Chapter 2 Comments and Responses to Comments

Table 2-1. List of Comments Received on the December 2003 Draft Joint Document for the U.S. 50/Missouri Flat Road Interchange Project

Figure 3
APE Map

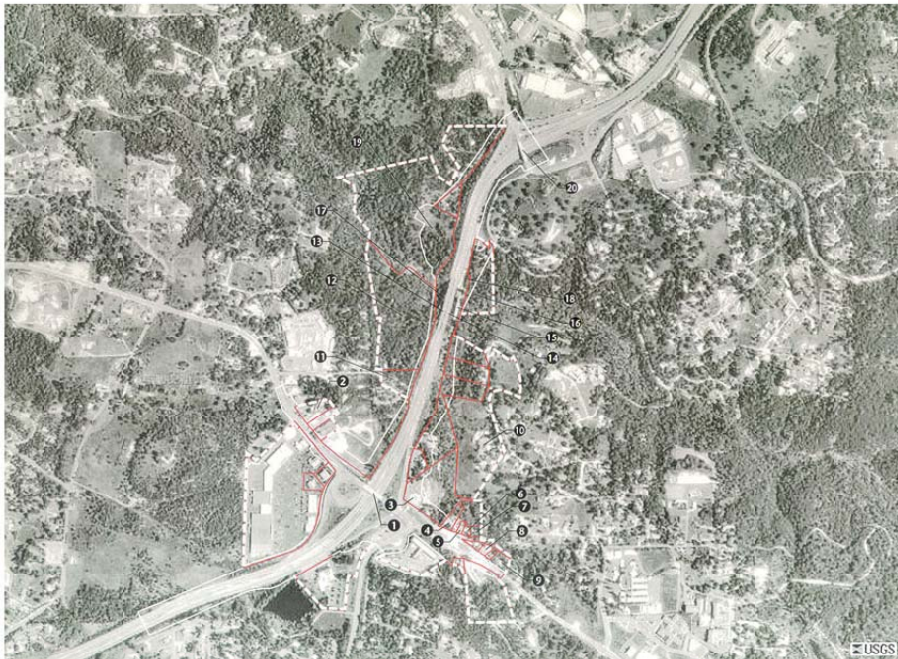
The Crawford Ditch is located more than 5 kilometers (3 miles) beyond the architectural Area of Potential Effect (APE). The architectural APE includes those parcels containing structures, in their entirety, where a partial or full acquisition would be needed for roadway right-of-way. The architectural APE encompasses the archeological APE that includes the project footprint and total existing and proposed right-of-way width. These definitions of the APE meet the Advisory Council on Historic Preservation regulations (36 CFR 800.2[c]). Figure 3 presents both APEs.
